Service Bulletin

Fuel Rail Pulse Dampener Retainer Clip

Product Safety Recall Under the Federal Boat Safety Act

Recall Bulletin

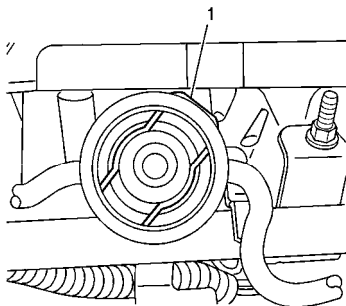
General Motors has decided that a defect, which relates to safety, exists in **certain** 2005-06 8.1L V8 (RPO L18) engines. Some of these engines have a condition in which the engine fuel rail pulse dampener retainer clip may fracture, resulting in inadequate retention of the dampener. If the dampener comes loose, a fuel leak may result and may cause a fire if an ignition source is present.

Note! Do not remove the fuel dampener from the fuel rail. If the dampener is removed the fuel dampener o-ring must be replaced.

14. Push down on the fuel dampener and remove the fuel pressure dampener clip (1) and discard.

15. Push down on the fuel dampener and install the fuel pressure dampener clip (1).
